From: Joseph O'Neill [joneill@jonesedmunds.com]
Sent: Tuesday, August 22, 2006 3:42 PM
To: Pelz, Susan
Cc: Joseph O'Neill; Richard Siemering; Carlos Restrepo
Subject: Section 8- Leachate Pipe Profiles

HILLSBOROUGH COUNTY
SOUTHEAST COUNTY LANDFILL
SECTION 8 SITE A
LEACHATE PIPE SETTLEMENT CALCULATION
FIGURE 1. SITE PLAN

Subject: Response to Request for Additional Information
Southeast County Landfill, Hillsborough County
Capacity Expansion Section 8
Certification of Construction Completion
Permit No. 35453-009-SC
Jones Edmunds Project No. 08449-020-01

HILLSBOROUGH COUNTY
SOUTHEAST COUNTY LANDFILL
SECTION 8 SITE A
LEACHATE PIPE SETTLEMENT CALCULATION
FIGURE 1. SITE PLAN

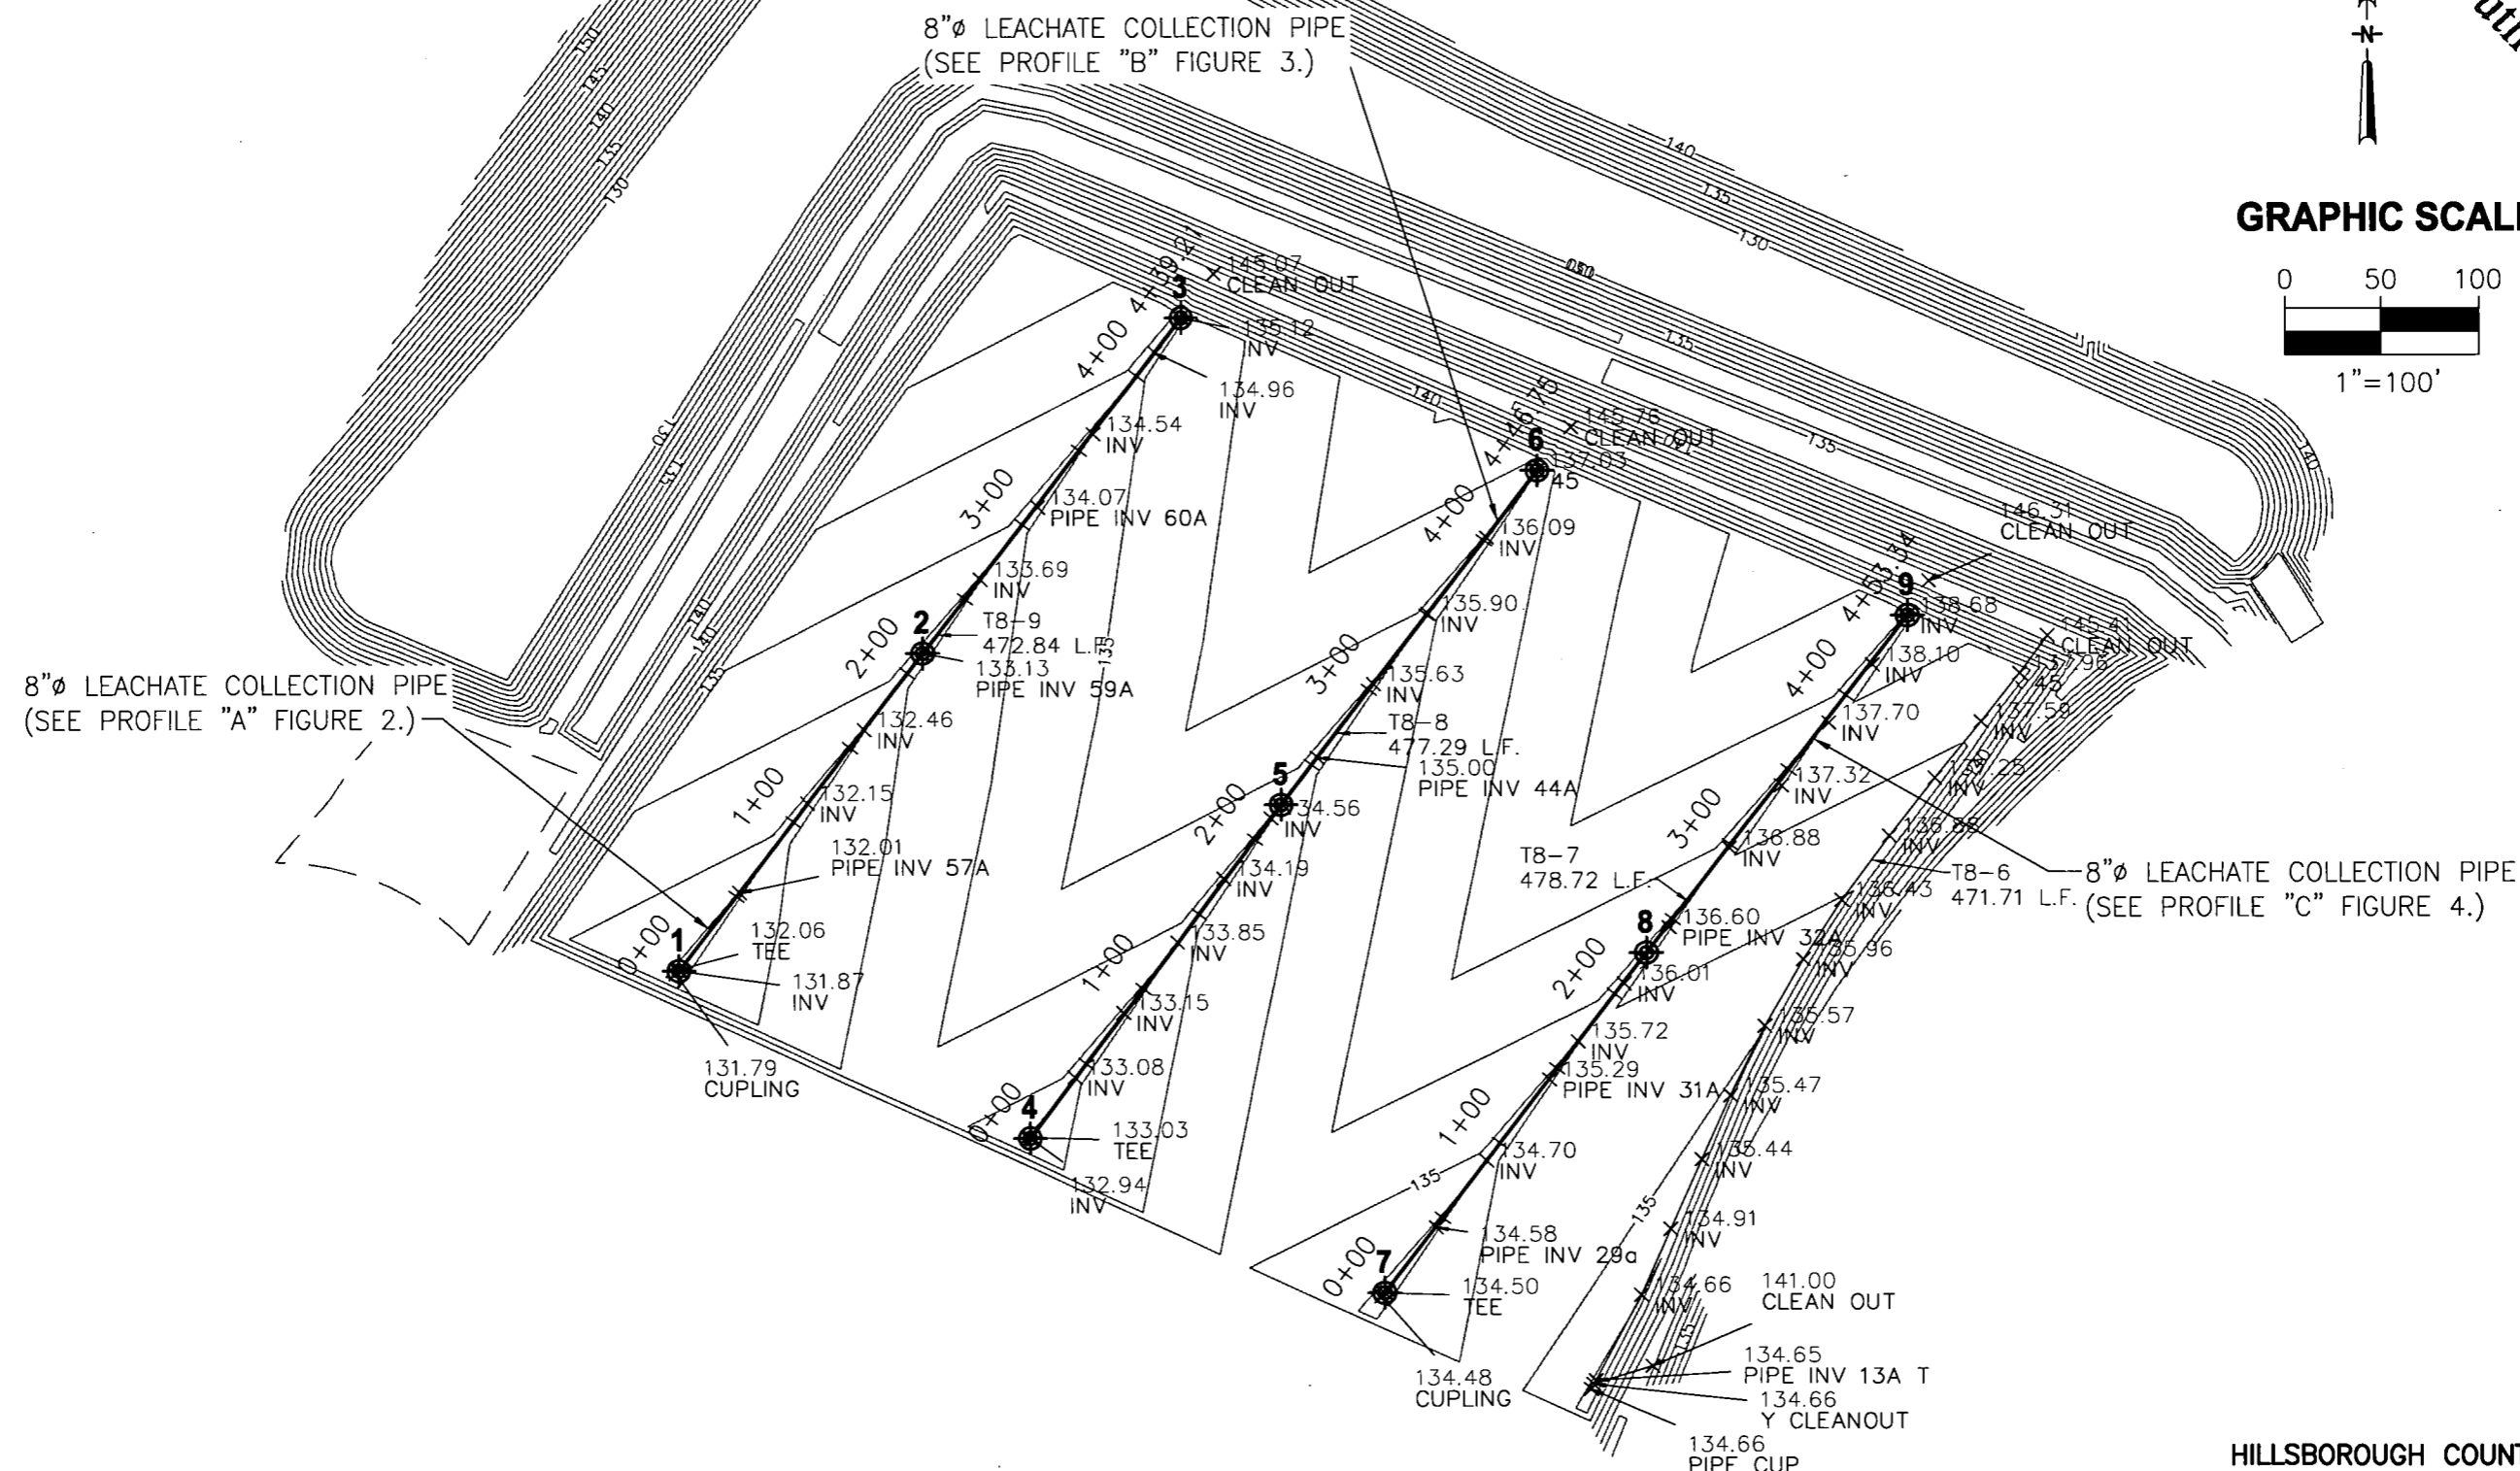
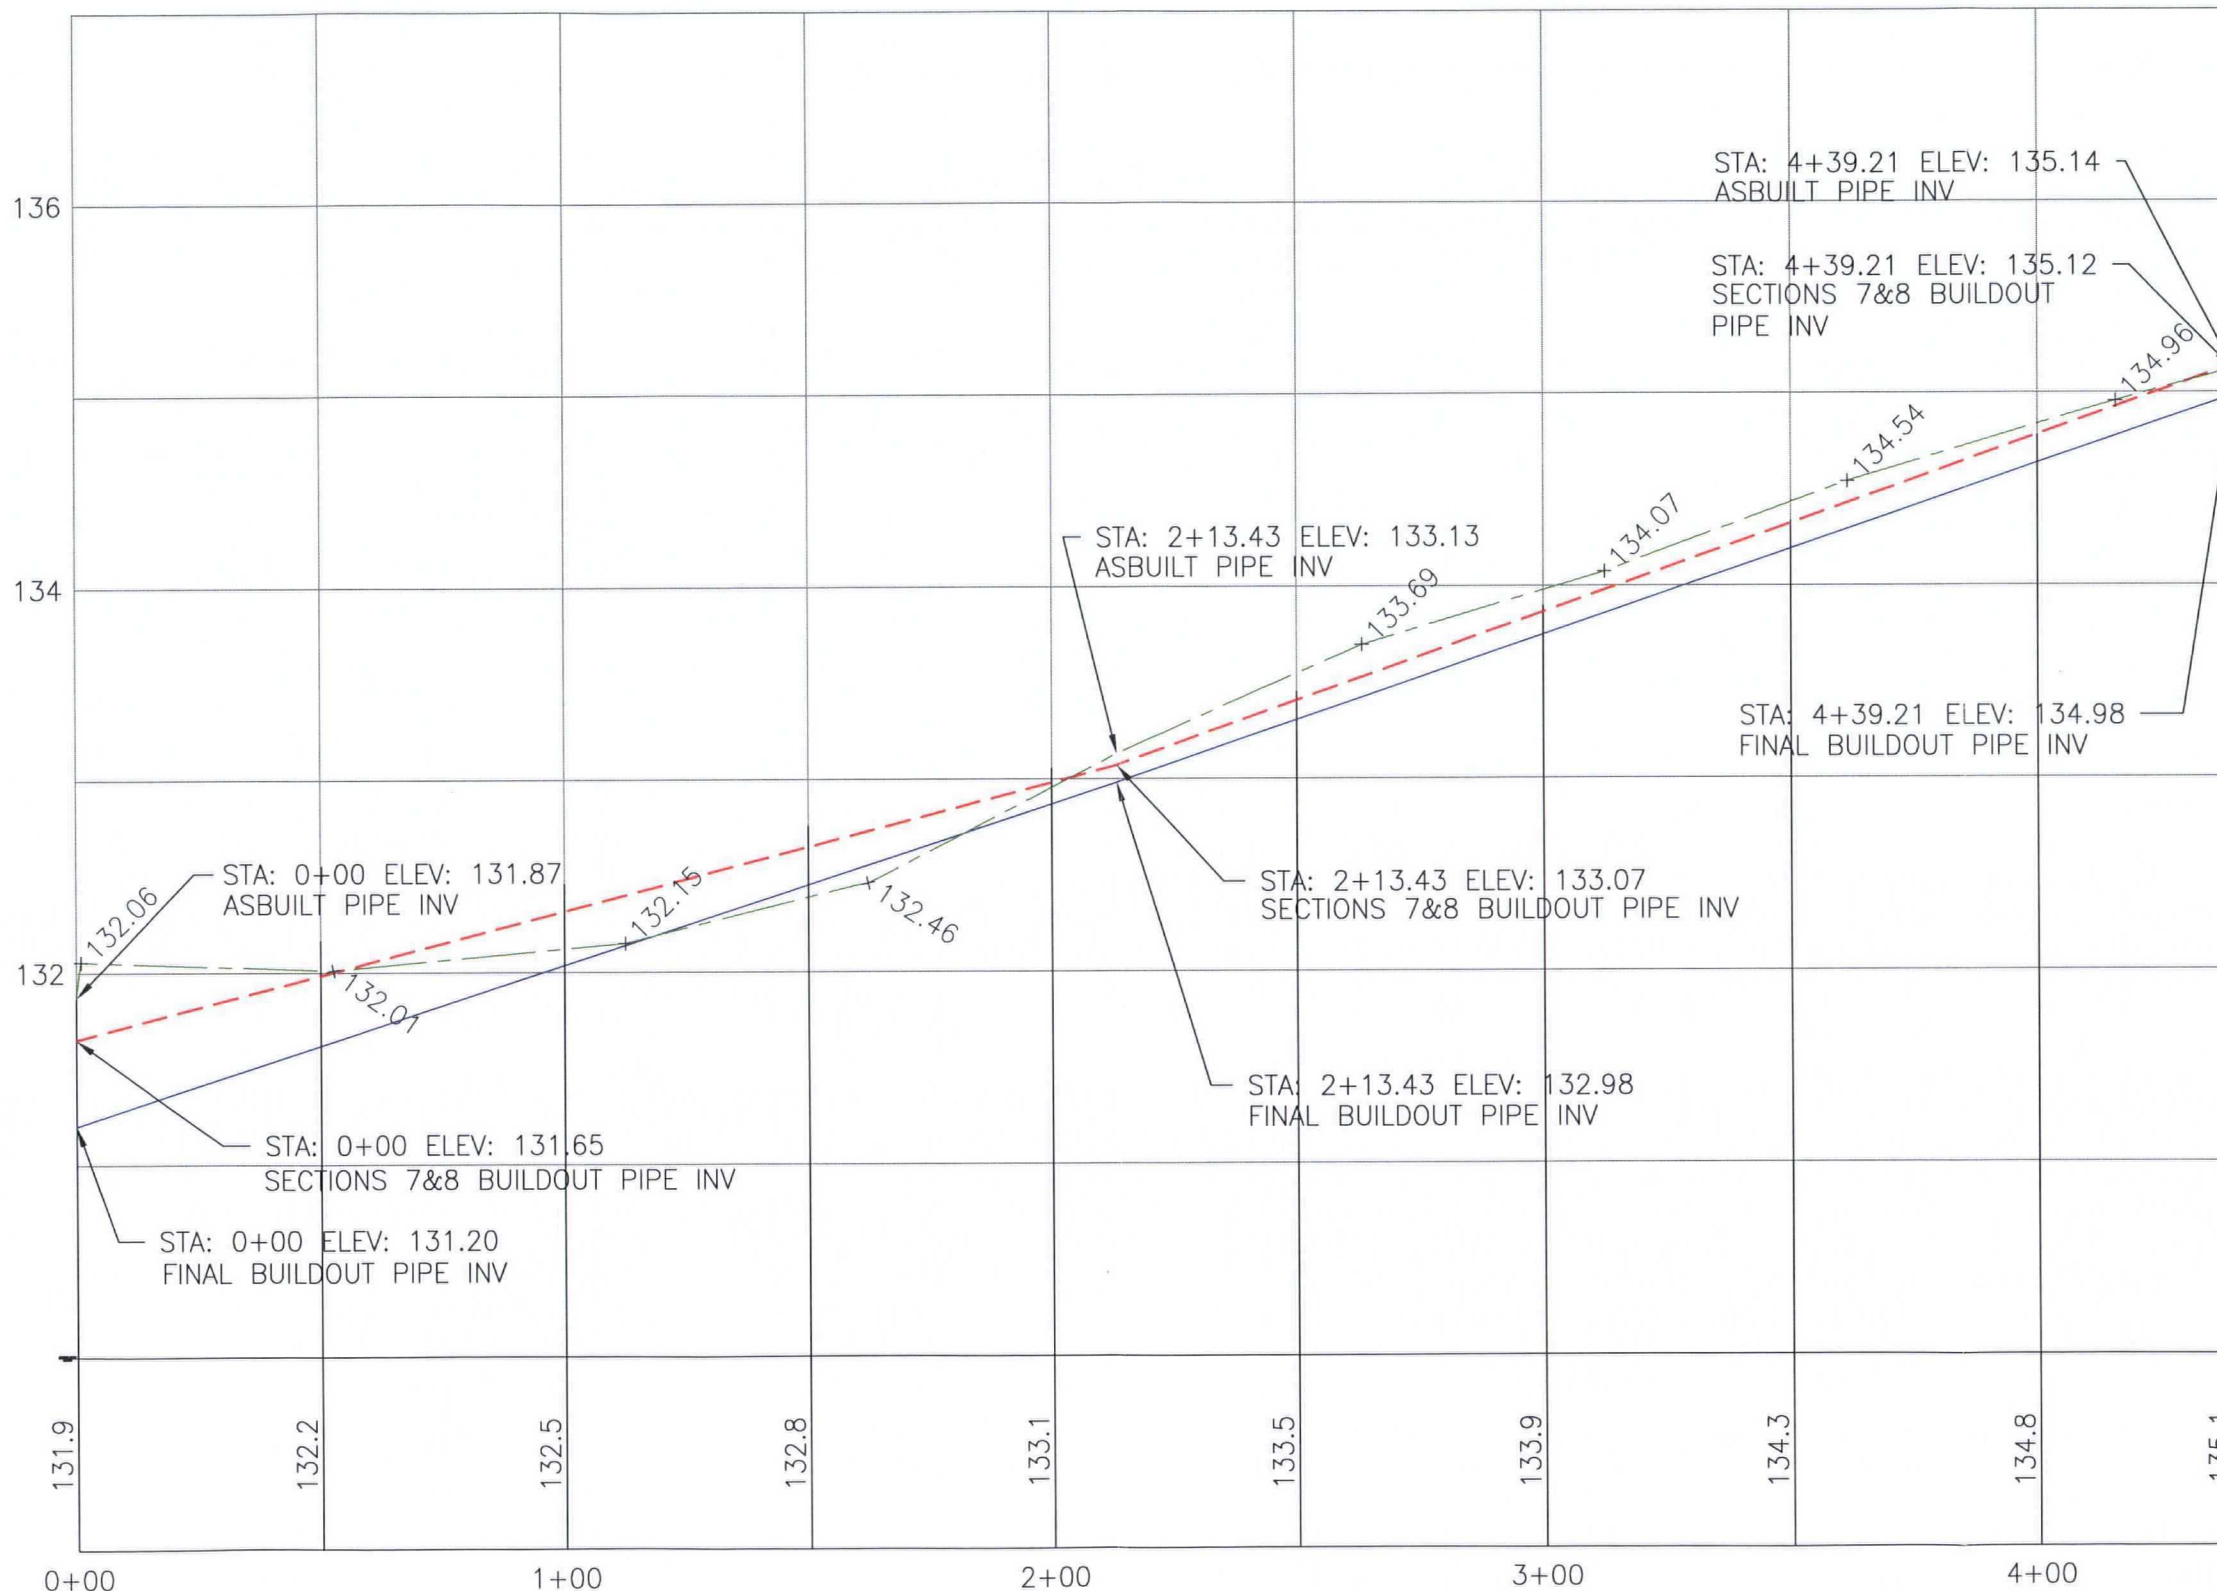
Comment 8) Please provide a Section 8 pipe profile for each leachate collection line with settlement estimates (Refer to the Department's Comment Number 4.a).

Response 8: Provided in Attachment 5 is a profile of each pipe based upon information supplied by Pickett and Associates during construction. In addition, settlement

estimates were preformed by SCS Engineer's for the filling of Sections 7, 8, and 9 and Final Buildout of Site "A". The as-built and projected pipe profiles are contained in Attachment 5. Conclusion, the pipes will have positive slope drainage towards Section 7.

SHORT RADIUS Hydraulic Excavator

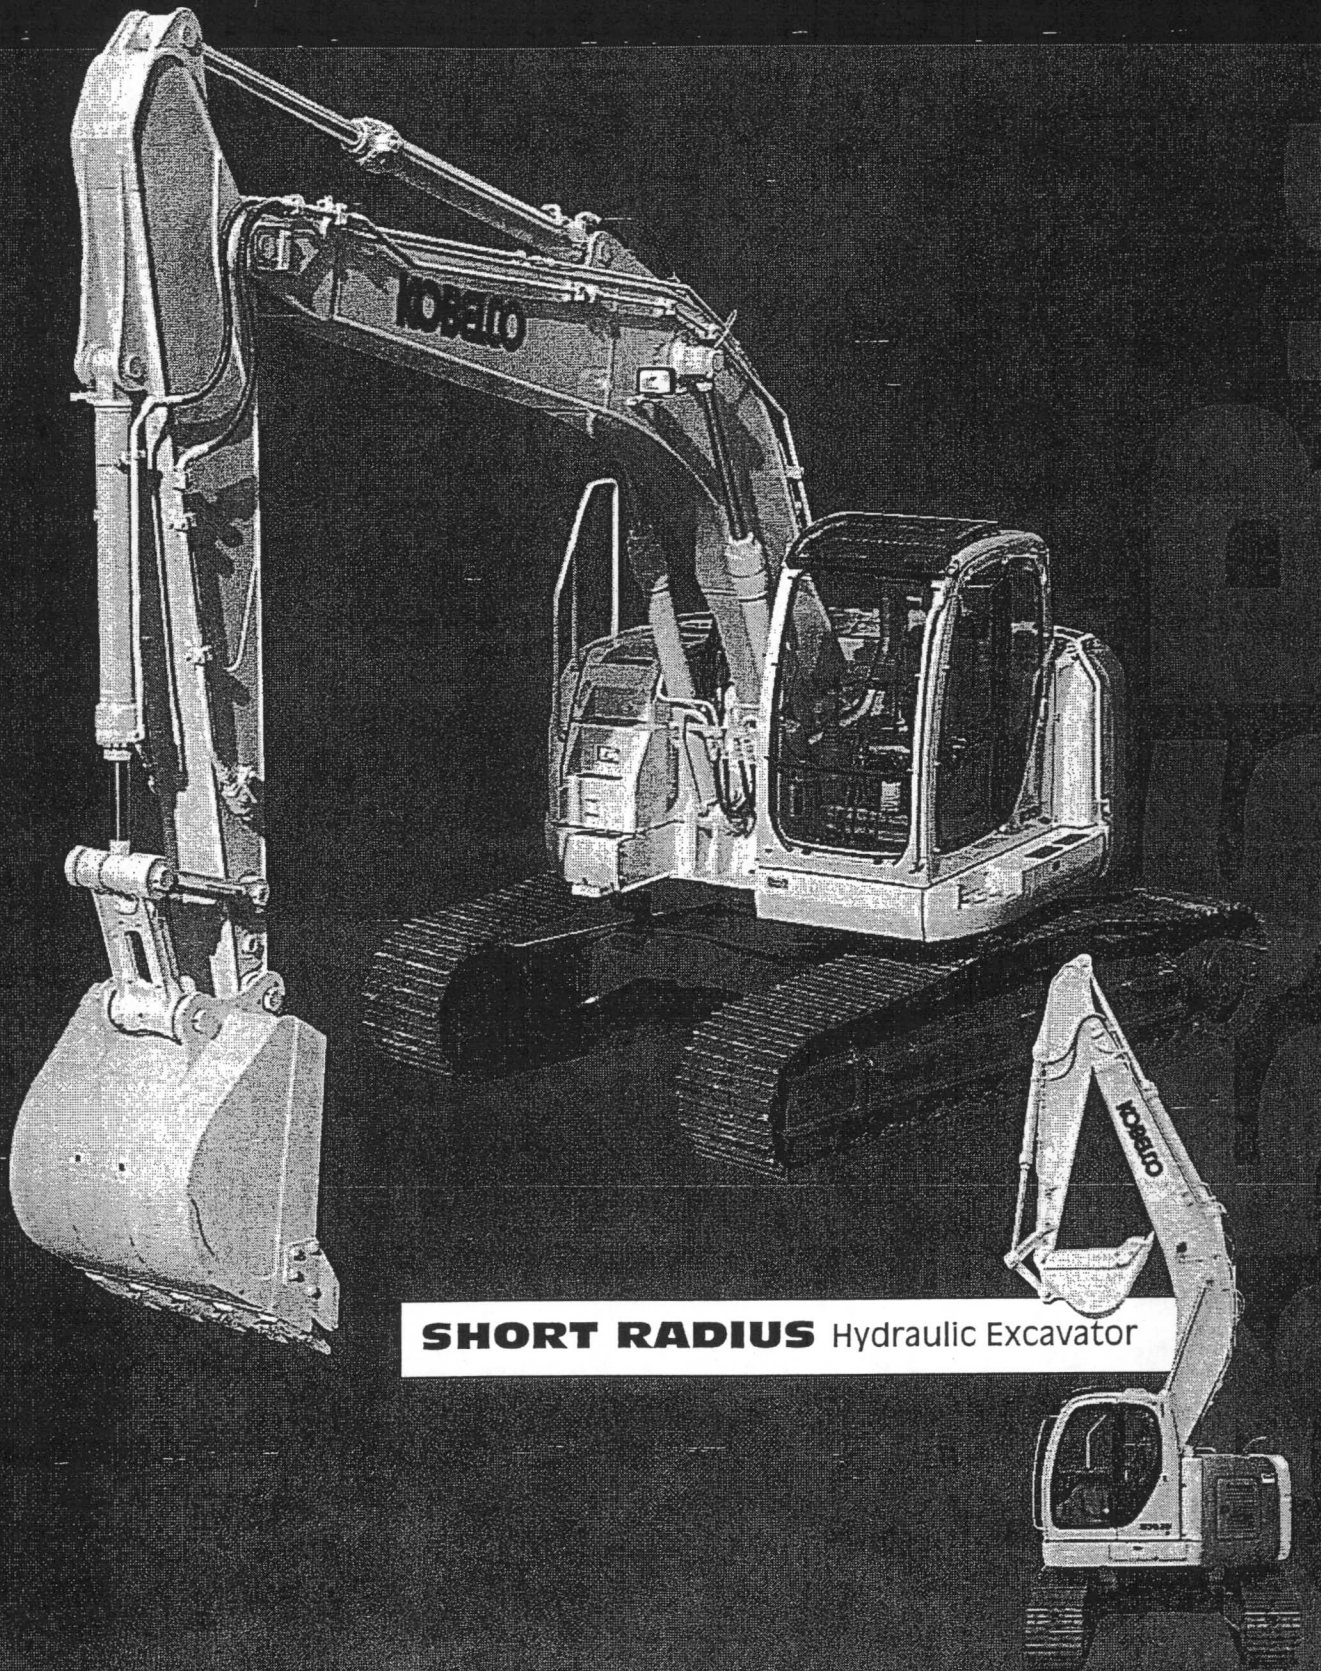
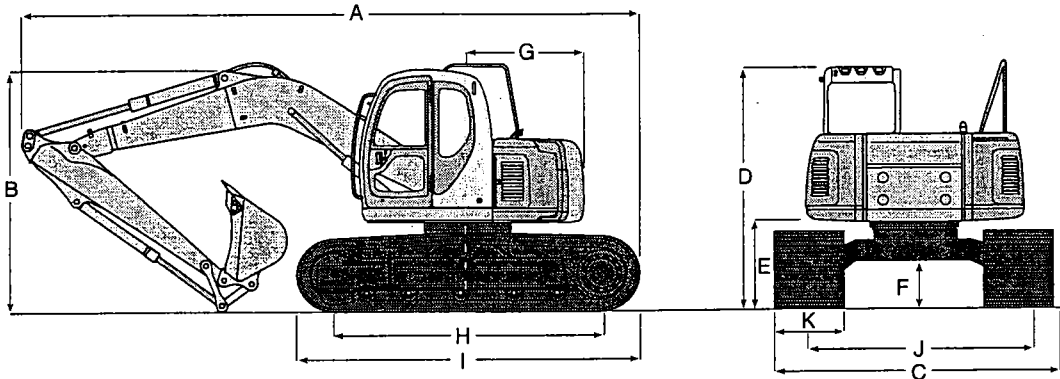
Comment 9) Please verify that the excavator shown in the photograph dated 11/01/05 is "low ground pressure" (Refer to the Department's Comment Number 9.a).

Response 9: The ground pressure of the Kobelco Model 235SR LC excavator shown in the photograph dated 11/01/05 has a ground pressure of approximately 5.6 pounds per square inch (psi). For comparison, the John Deere 700H LGP (Low Ground Pressure) dozer that was used to spread the drainage sand across Section 8 has a slightly higher ground contact pressure of 5.5 psi. Therefore, the excavator shown in the photograph dated 11/01/05 is similar to a "low ground pressure" dozer. Please refer to the documentation of the Kobelco 235SR LC and John Deere 700H LGP vehicles provided in Attachment 6
